Docket: NRC-2011-0259
Draft Environmental Assessment and Draft Finding of No Significant Impact

Comment On: NRC-2011-0259-0001
Florida Power & Light Company, Turkey Point, Units 3 and 4; Draft Environmental Assessment and Draft Finding of No Significant Impact Related to the Proposed License Amendment to Increase the Maximum Reactor Power Level

Re: Proposed Turkey Point Power Plant Uprate Units 3 and 4 (ME4907 and ME4908)
Draft Environmental Assessment and Finding of No Significant Impact

FPL Monitoring Stations Location Map

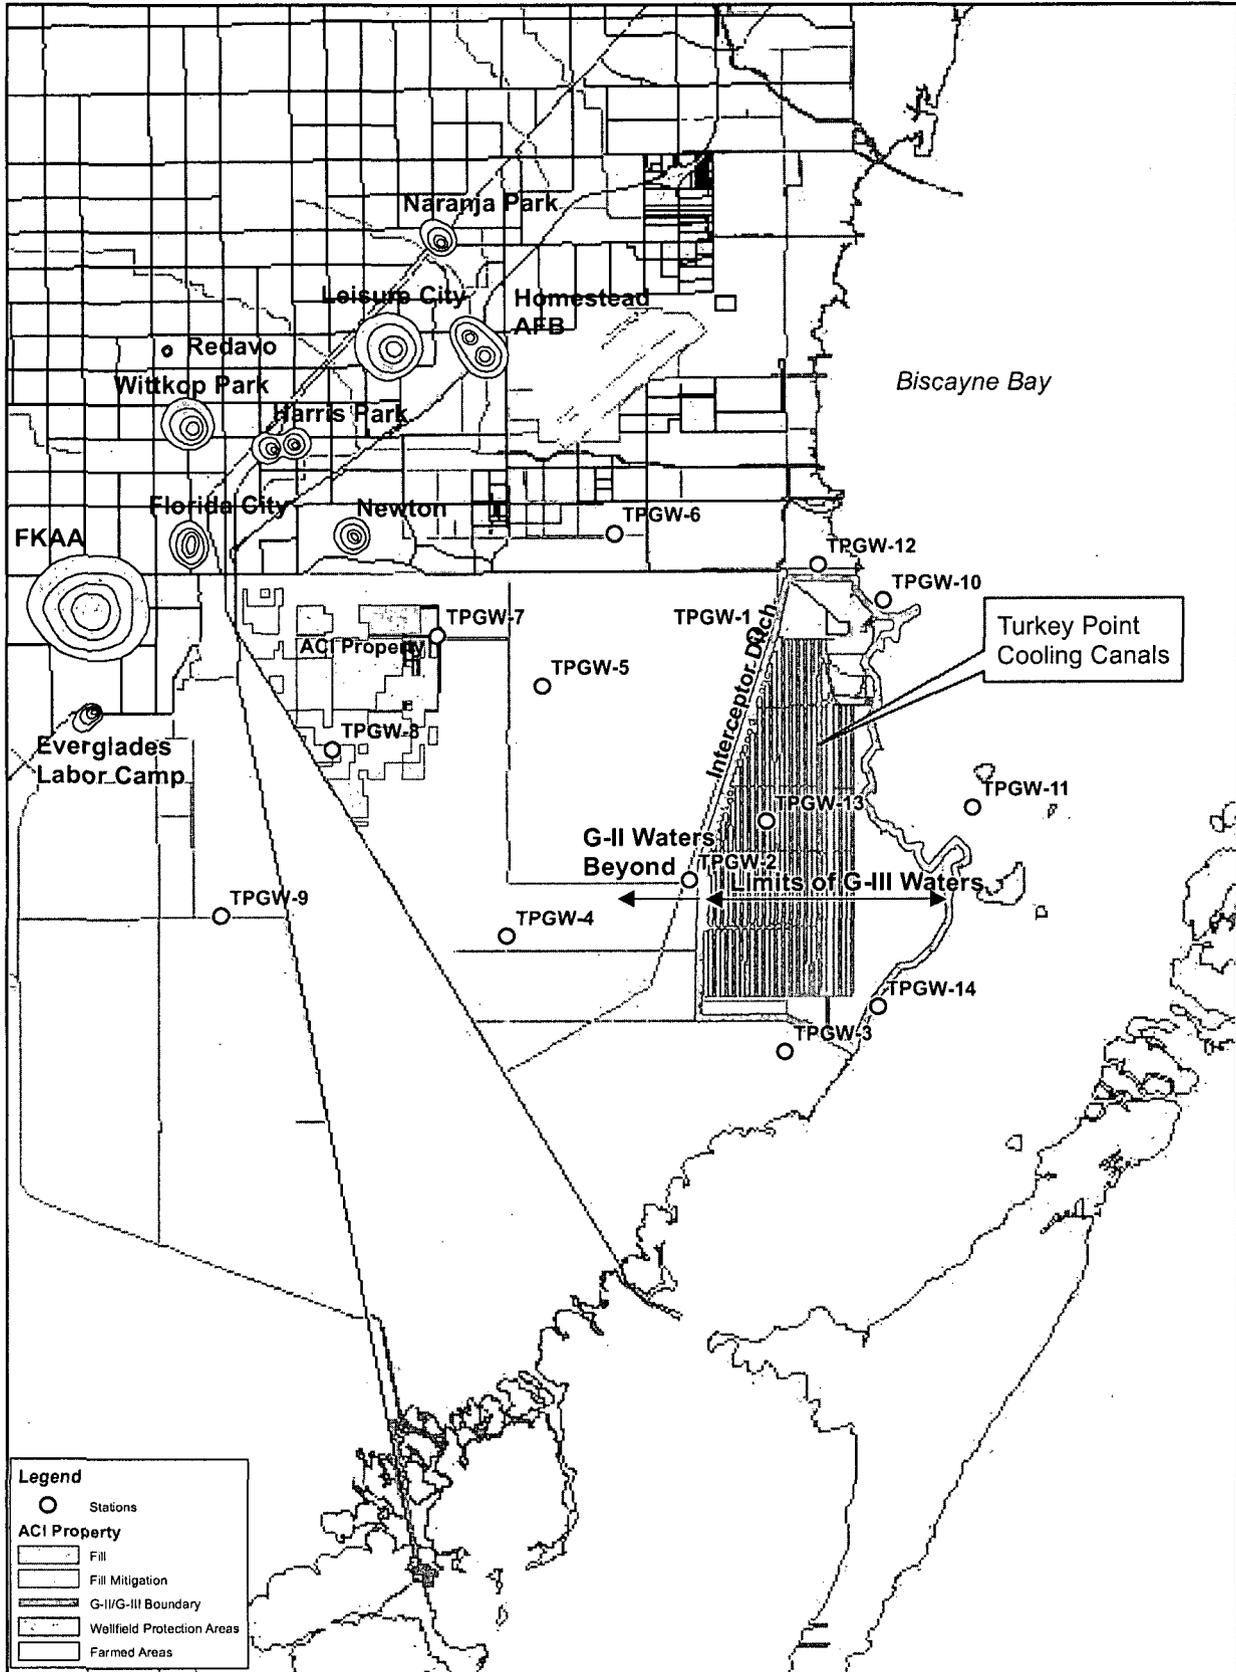
The economy in the South Miami Dade County area is heavily dependent on farming. Not only is a significant portion of our land farmed, as shown on Figure 1 there are many other large farms in the area. All of these farmed areas rely upon groundwater for irrigation that is also potentially impacted by the continued salt front migration.

FPL Monitoring Stations Deep Chloride - December, 2010

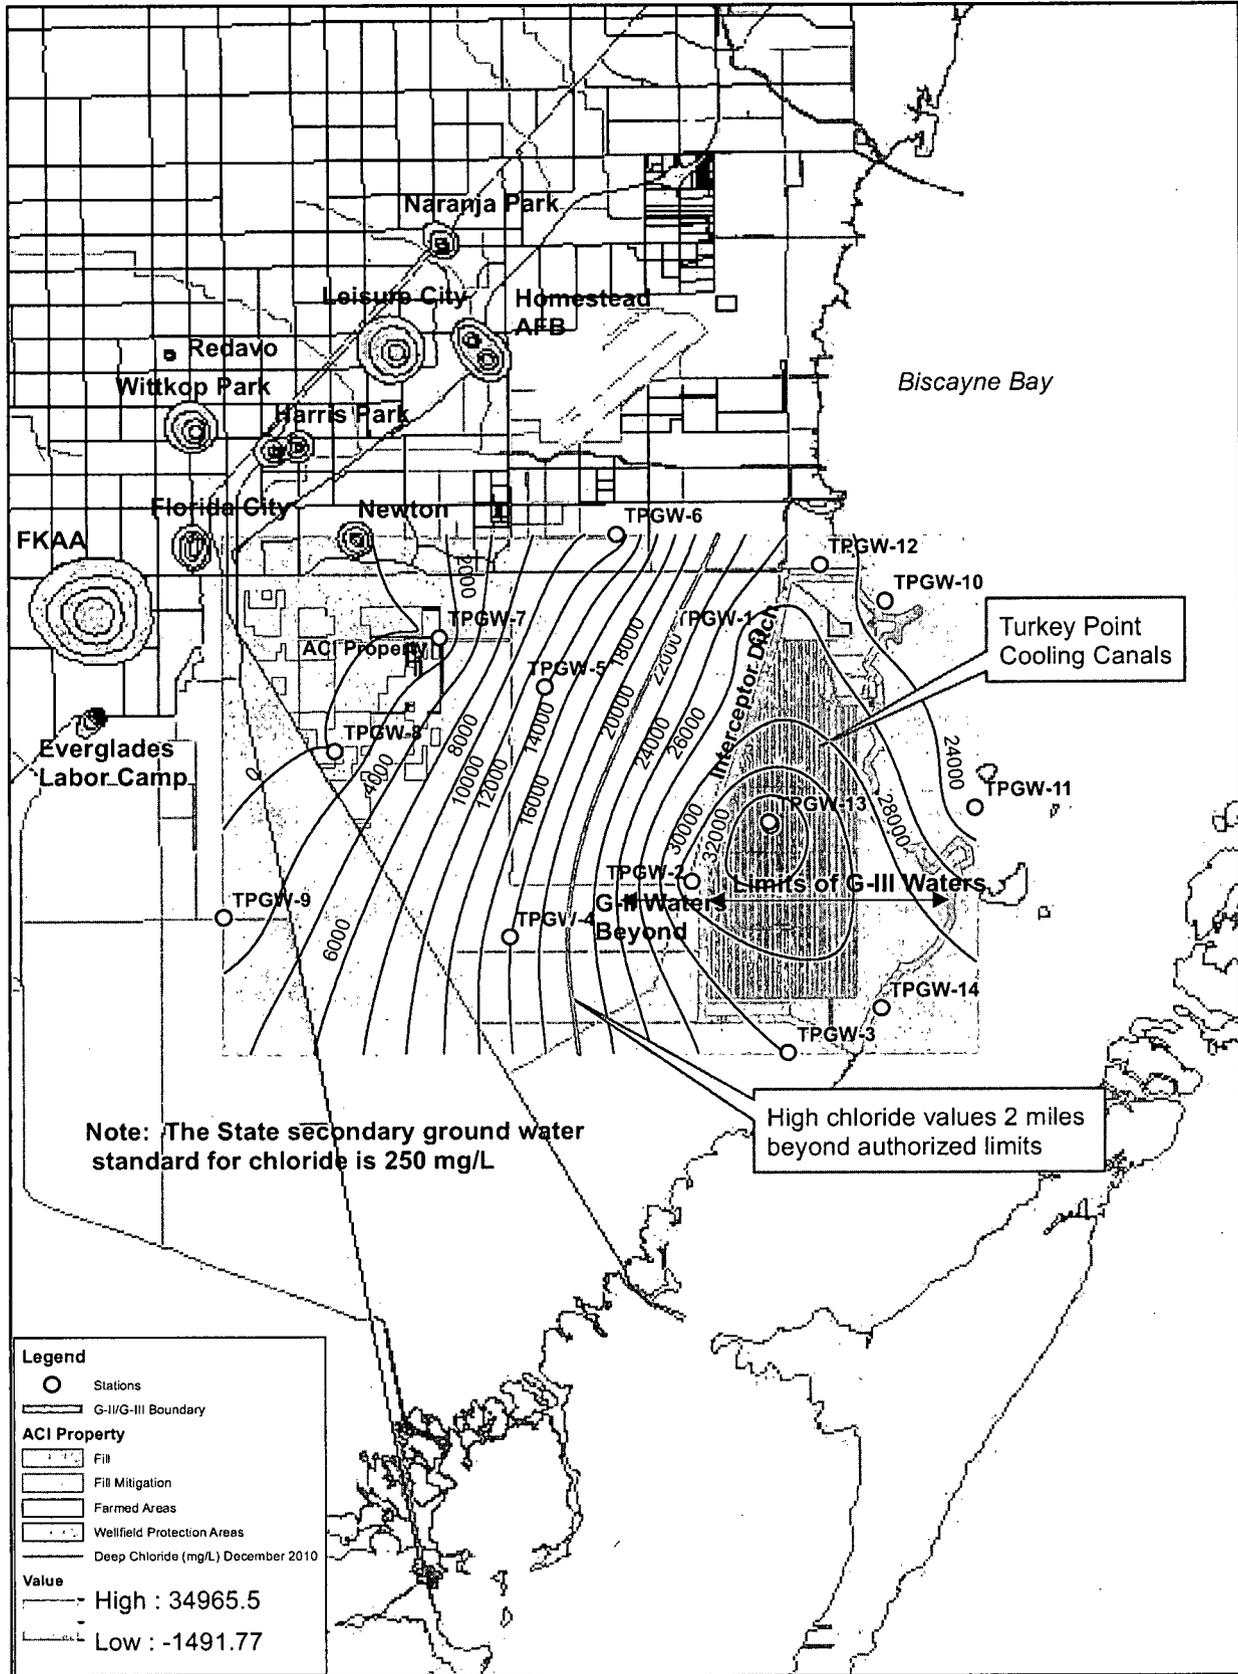
This statement suggests that the existing monitoring data does not show an adverse impact. EAS Engineering, however, using FPL's own historical monitoring data, has shown that contaminants from the CCS (chlorides, sulfates and tritium in particular) have travelled a mile or more to the west of the interceptor ditch, resulting in violations of G-II ground water standards in this area (See the attached figures), which is the boundary of the no discharge NPDES permit.

additional monitoring included in the 5th supplement to the original 1972 agreement between FPL and the SFWMD documents the problem even more clearly. See figures 2 & 3.

1. FPL claims that the cooling canal is a closed system, but obviously it is not. FPL's monitoring data shows that the unlined cooling canal system exchanges water with adjacent ground water. FDEP designated the groundwater within the cooling canal system as G-III waters (non-potable aquifer not subject to compliance with groundwater standards) and the NPDES Permit only authorized a discharge to those G-III waters. FPL's groundwater monitoring data shows that contaminants from the cooling canals have migrated west of L-31E and the interceptor ditch into G-II waters (See the attached figures).
